2472 Dix – Gas Station Expansion

Site Plan Review

Applicant	Y & A Investments, LLC, represented by MA Designers, Inc.
Project	Gas Station Expansion
Address	2472 Dix Hwy, Lincoln Park, MI 48146
Date	September 14, 2022
Request	Site Plan Review

PROPOSED SITE PLAN

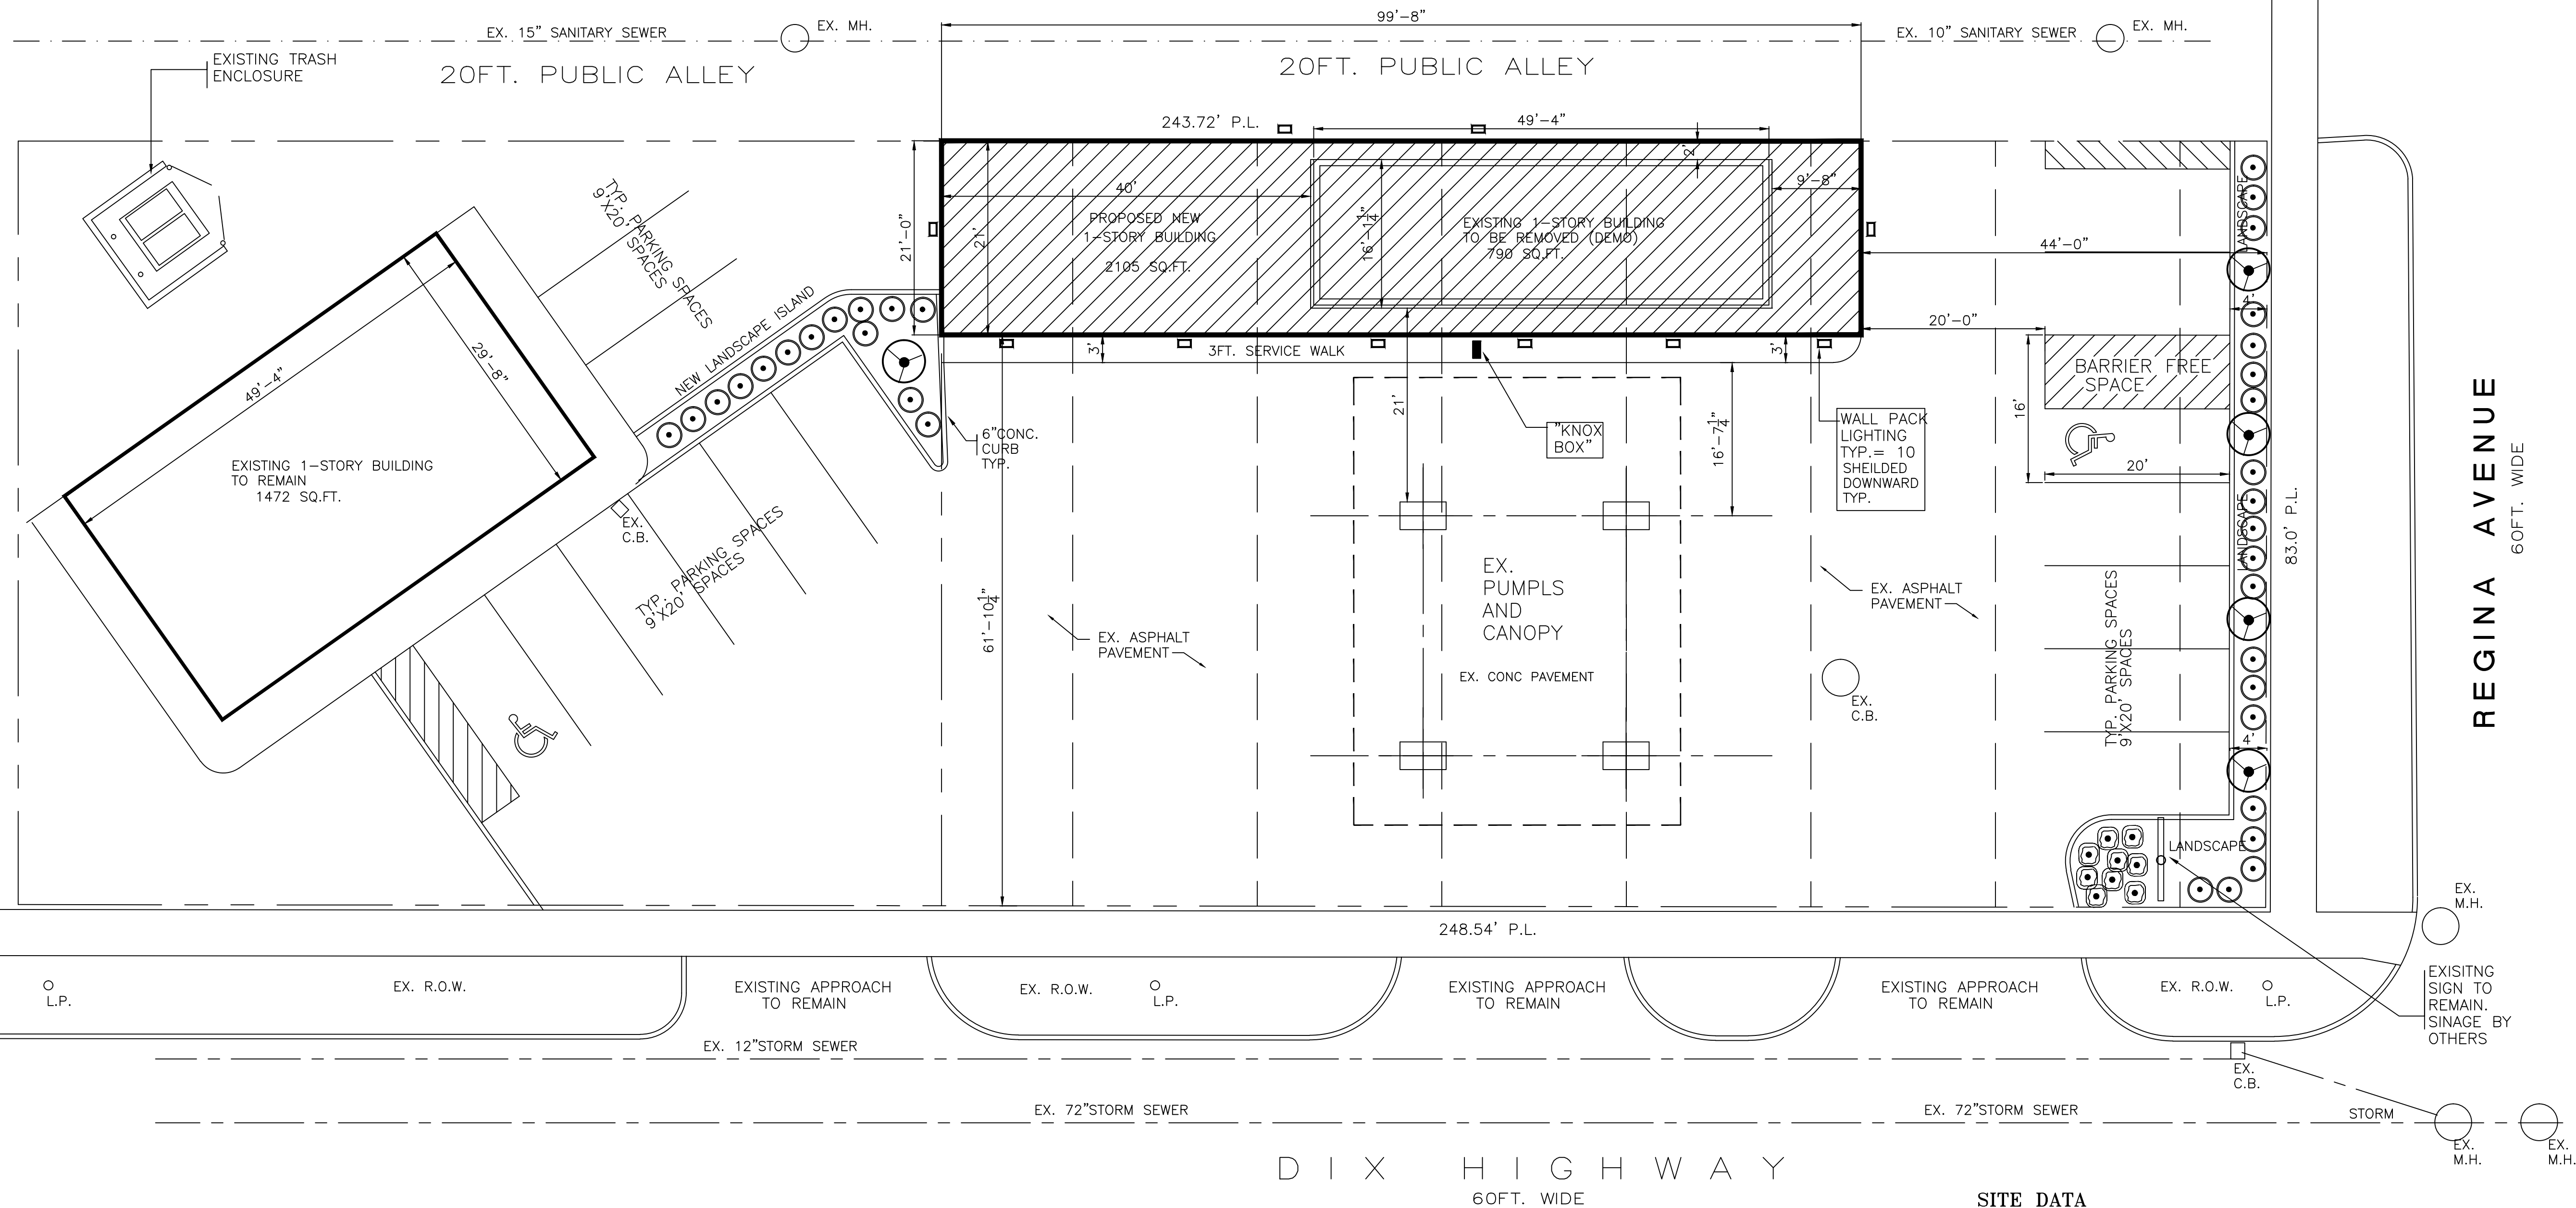
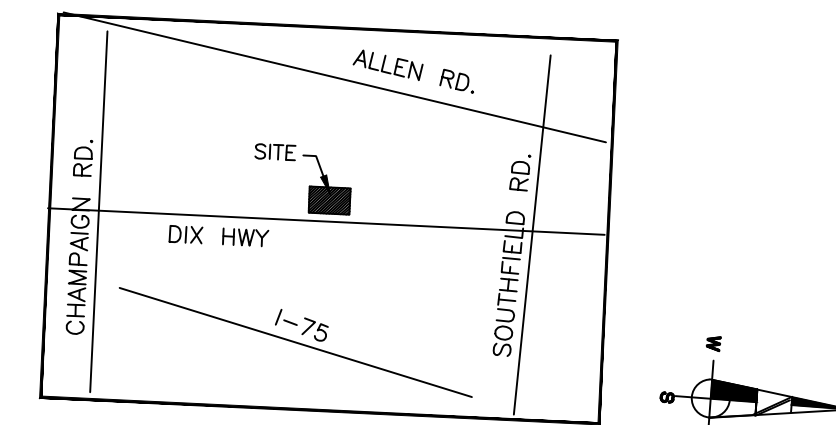
Required	Proposed	Compliance
Parking Area Type B §1290.05	Adequate means of ingress and egress shall be provided and shown	Existing ingress and egress provided via Dix Hwy.	Met
	Parking facilities, access drives, and maneuvering aisles shall be hard surfaced with concrete or plant-mixed bituminous material, maintained in a usable dustproof condition and graded and drained appropriately	Parking area has existing asphalt; however, asphalt appears to be in poor condition and will likely need to be replaced.	INQUIRY
	Concrete curbs and gutters	Parking lot drains directly onto sidewalk and alley.	NOT MET
	When adjoining residential property and/or a residential street or alley: 6' solid masonry wall, ornamental on both sides, with bumper guards	No wall provided.	NOT MET
	All street boundaries of such parking facilities, where residential property is located on the opposite side of the street, shall be treated the same as set forth in Section 1290.04, Off-Street Parking A Areas; Residential Districts Adjoining Business or Industrial Districts.	No wall provided.	NOT MET

- Applicant shall ensure that the existing asphalt meets City standards.
- Applicant shall provide the required 6’ solid masonry wall, ornamental on both sides, with bumper guards, on the east property line abutting the residential alley.

Gross Floor Area	Loading Spaces – Required	Loading Spaces – Provided	Compliance
2,001 – 5,000 sf	1	No loading space shown.	INQUIRY

- Applicant shall provide the required loading and unloading space in accordance with §1290.09 of Lincoln Park Zoning Code.

In the proposed site design, cars which are using the fueling pumps block ingress and egress from the middle curb cut, effectively rendering it useless and potentially dangerous. The existing driveways do not meet the standards for number, size, or location. Because the project is redeveloping an existing site, the Planning Commission has the authority to apply the standards to the maximum extent possible if it determines that compliance with all the standards of this section is unreasonable.

- Applicant shall propose to close the middle driveway that is located between the egress and ingress driveways. The location of the driveway impacts of the pedestrian and vehicular circulation on the site.*
